**RANGELINE 90 SUBDIVISION, UNIT ONE,**  
**(REVISED) RESUBDIVISION OF LOT 6,**  
**RESUBDIVISION OF PARCEL 6B AND A PORTION**  
**OF PARCEL 6A**

APPLICATION NUMBER 15 DATE January 19, 2006

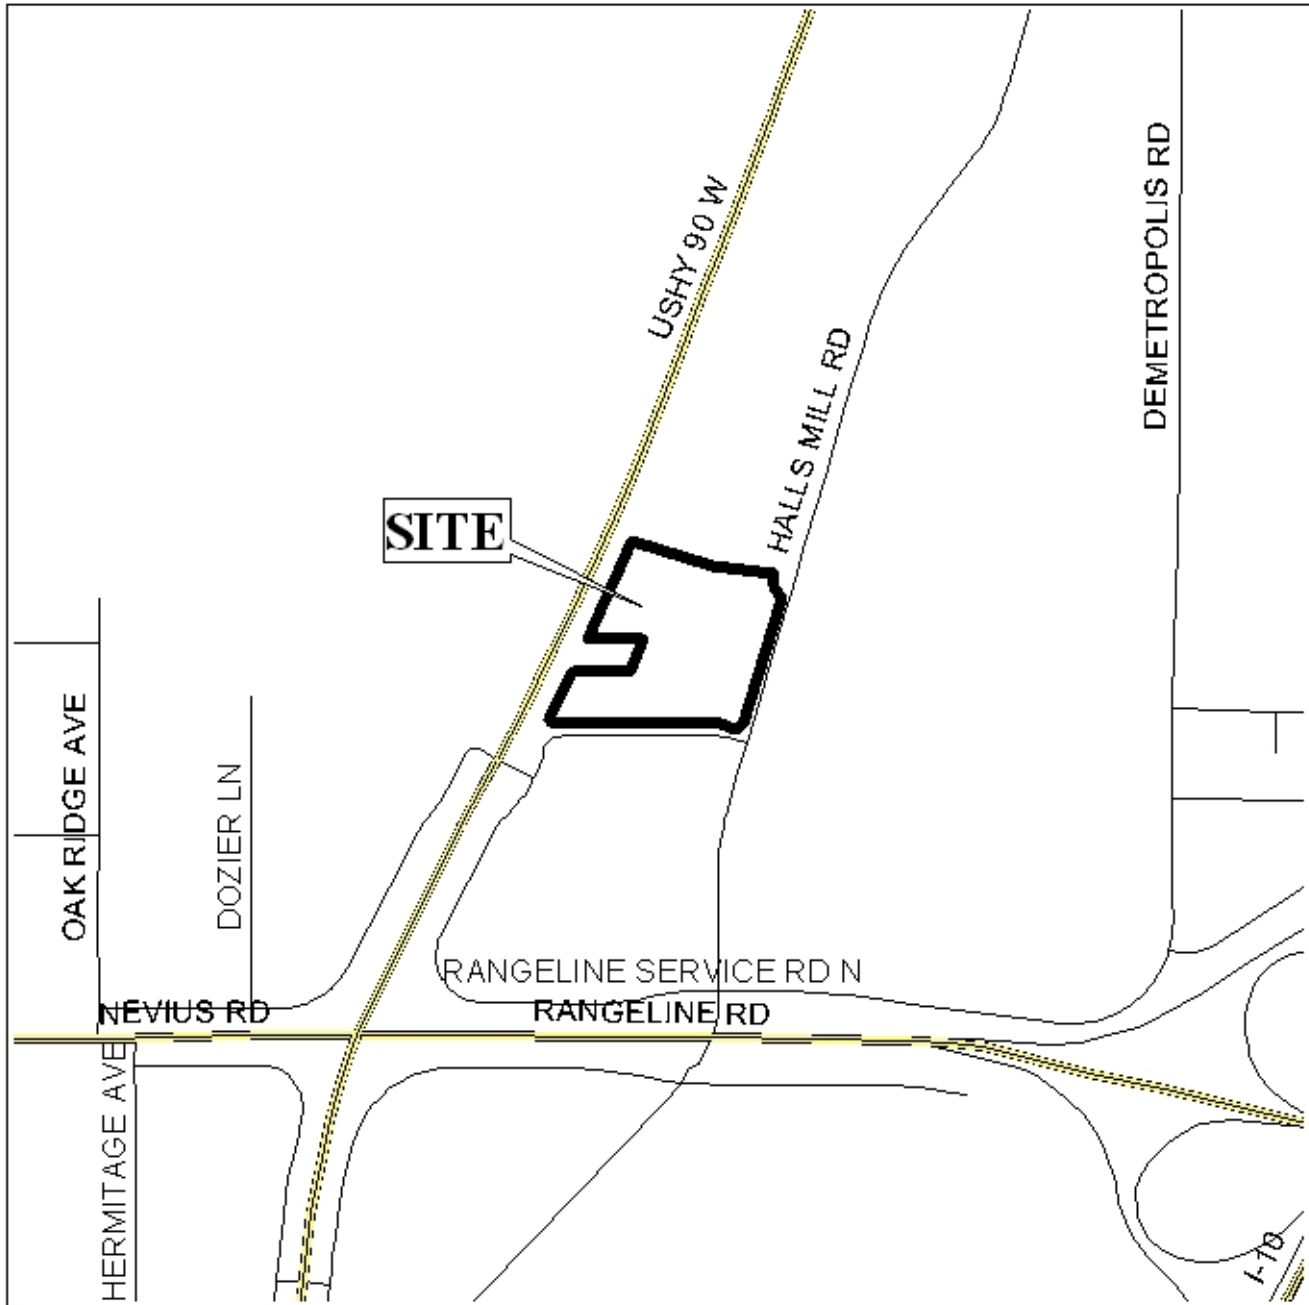
Engineering Comments: Must comply with the Mobile County Flood Damage Prevention Ordinance.

In June 2005, Lot 2 was approved by the Commission but since has not been recorded. Therefore, Lot 2 should be included in the subdivision prior to Planning Commission approval and recording of plat.

Additionally, as the site fronts a major and a collector street, proper access management and orderly circulation from the proposed development is a concern. Therefore, the placement of a note on the final plat stating that the number, size, location and design of all curb cuts are to be approved by ALDOT and County Engineering should be required. The approval of the original Resubdivision of Lot 6 limited access to U.S. Highway 90 to the existing curb cuts because of their alignment with the existing median cuts. Moreover, the plat reflects an easement for ingress and egress to maintain compliance with the original condition.

A detention area is shown on the plat, thus the placement of a note on the final plat stating that maintenance of the detention area shall be the responsibility of the property owner should be required.

This site is located in the County, thus a note should be placed on the final plat stating that any lots which are developed commercially and adjoin residentially developed property must provide a buffer, in compliance with Section V.A.7. of the Subdivision Regulations.

The plat meets the minimum requirements of the Subdivision Regulations and is recommended for Tentative Approval subject to the following conditions: 1) the approval of all applicable federal, state and local agencies prior to the issuance of any permits; 2) the placement of a note on the final plat stating that curb cuts to U.S. Highway 90 is limited to

the existing cut which aligns with the existing median cut; 3) all detention areas be indicated on the final plat with a note stating that the maintenance thereof is the responsibility of the property owner; and 4) the placement of a note on the final plat stating that any property that is developed commercially and adjoins residentially developed property shall provide a buffer, in compliance with Section V.A.7. of the Subdivision Regulations.
